Evaluation of Modeling Methodology Used by EPA to Determine a Benzene Fenceline Monitoring Proposed Action Level in the Coke Ovens Proposed Rule

AECOM
Feb. 2, 2024

Figure 1. Modeled Sources and Polar Grid Receptors at AM-Warren-OH

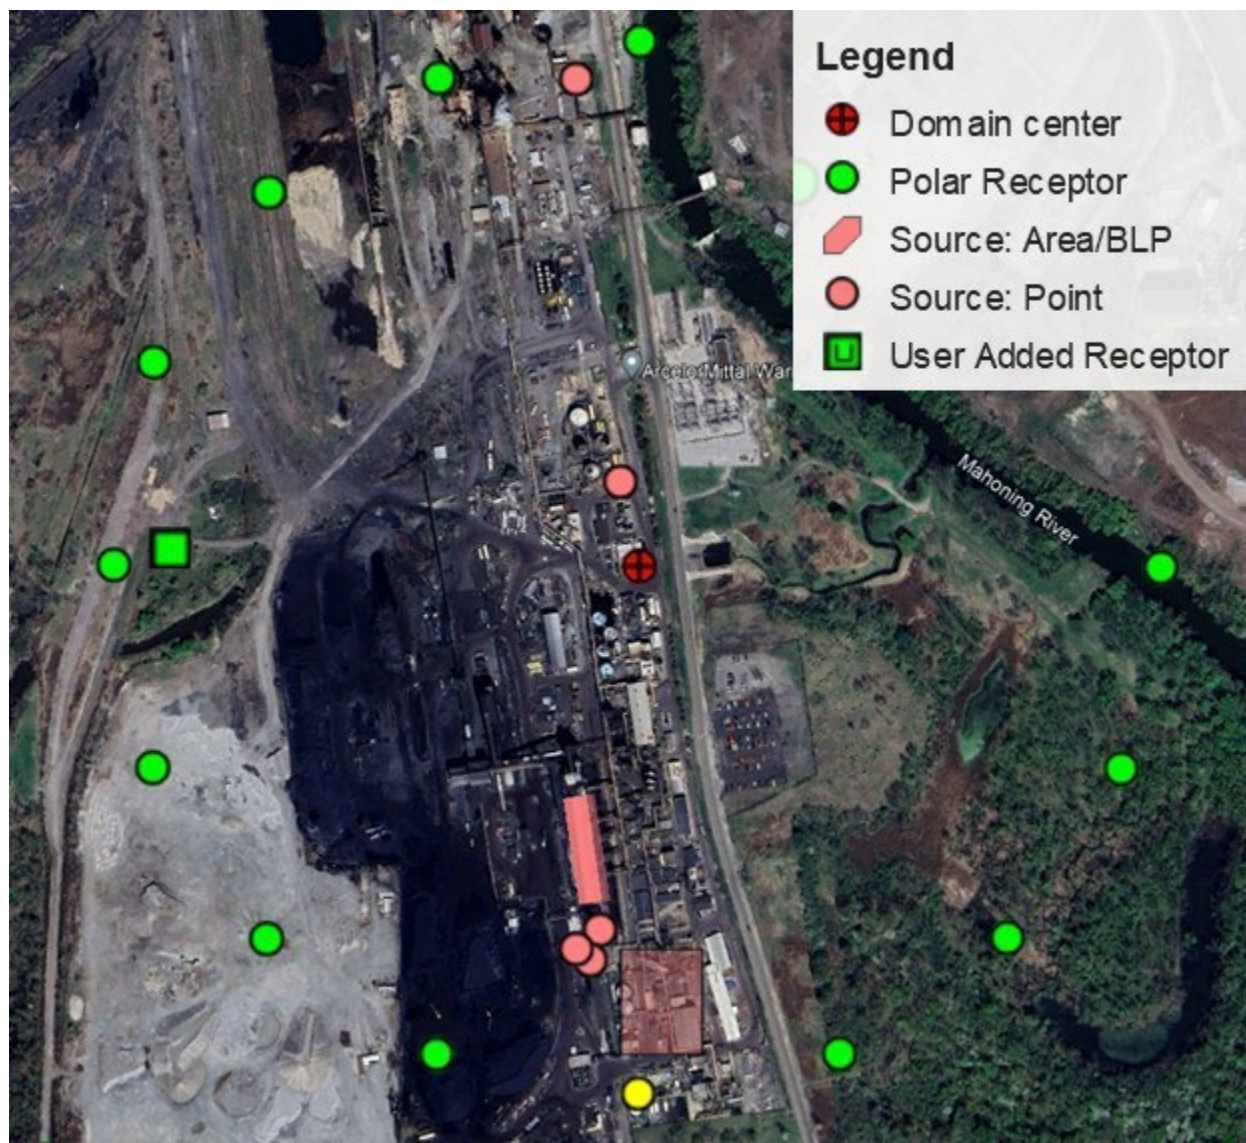
The methodology EPA used in the Proposed Rule for estimating fenceline benzene concentrations underestimates the concentration of benzene at the actual coke facility fenceline. EPA’s method described above merely approximates a fenceline for each facility using a polar receptor grid, which incorrectly assumes each facility’s fenceline is circular (as shown in Figure 1). Using a polar receptor grid does not accurately represent the true fenceline of a byproduct recovery coke facility where benzene monitors would be located under the proposed fenceline monitoring requirements. Many or all of the polar grid receptors at each facility EPA modeled are located outside of the facility’s actual fenceline, resulting in lower modeled concentration estimates than what may be measured by monitors at the true fenceline of the coke facility. All byproduct recovery coke facilities have irregularly shaped or elongated fencelines similar to that shown in Figure 2 for the AM-Warren-OH facility, which was modeled by EPA to have one of the highest fenceline concentrations.

Furthermore, EPA’s modeling was conducted using actual emissions for byproduct recovery facilities, rather than allowable emissions, which understates the predicted fenceline benzene concentrations that inform the action level. An action level

established based on actual emissions is not appropriate and would not properly account for expected emission rates that would occur when production is at or near permitted/allowable capacity. Because benzene emissions associated with non-category sources at a facility have greater uncertainty, and are based on actual emissions rather than allowables, the modeled emission rates should be scaled up based on permitted/allowable throughput. Emissions fluctuate frequently over time and the action level that EPA has proposed by using actual emissions for byproduct recovery sources does not take into account these fluctuations. When a facility's source category allowable emissions are included in the analysis, the monitored benzene concentrations are likely to exceed the proposed action level even though the facility is operating within allowable permit limits.

Figure 4. Refined Modeled Fenceline Receptors and Sources at AM-Warren-OH

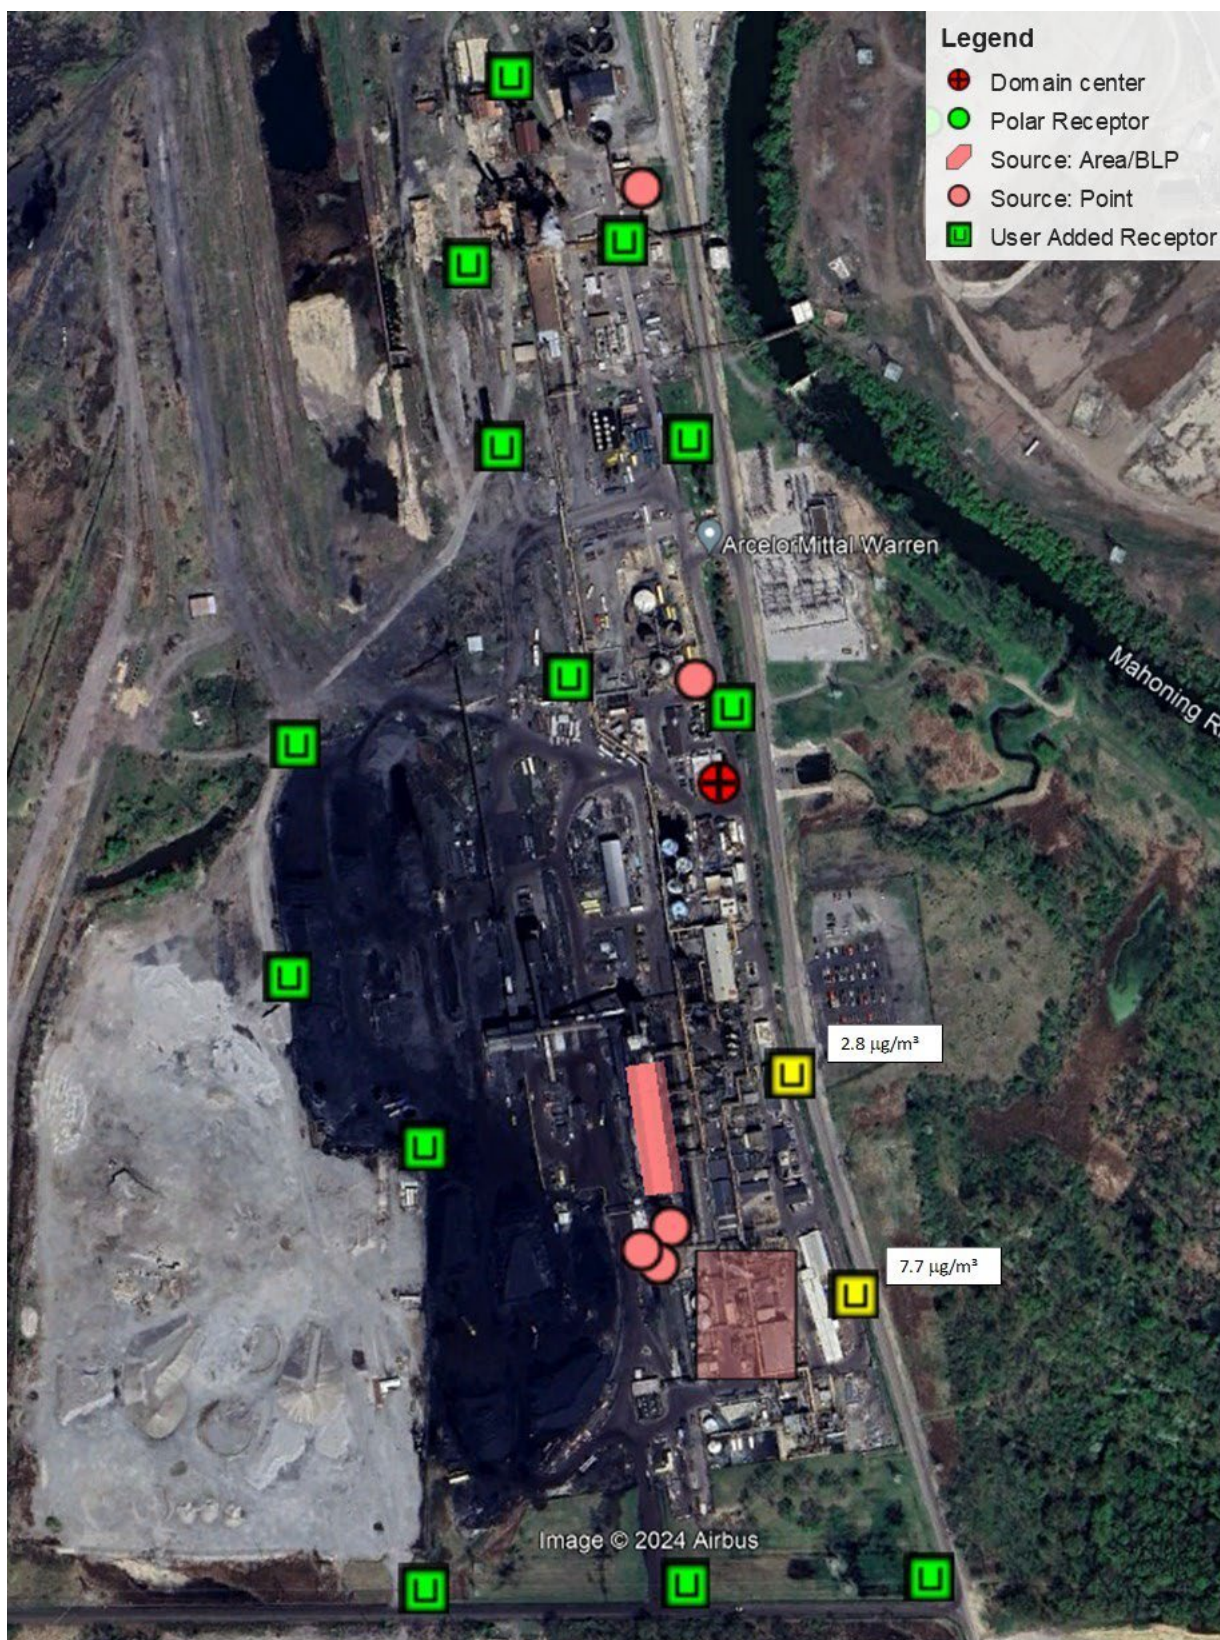
Because the receptor spacing for the initial remodeling run was very wide (approximately 150 meters), additional receptors were added at approximately 25-meter spacing to refine the fenceline remodeling as shown in Figure 4. The highest remodeled fenceline concentration of $11.3 \mu\text{g}/\text{m}^3$ was nearly four times the proposed benzene action level ($3 \mu\text{g}/\text{m}^3$) in the Proposed Rule.

If EPA decides to move forward with finalizing any fenceline monitoring requirements, EPA must revise the modeling methodology to establish an action level that accurately reflects the expected concentrations that would be measured at the true fenceline of each facility using allowable emissions for all facility sources.
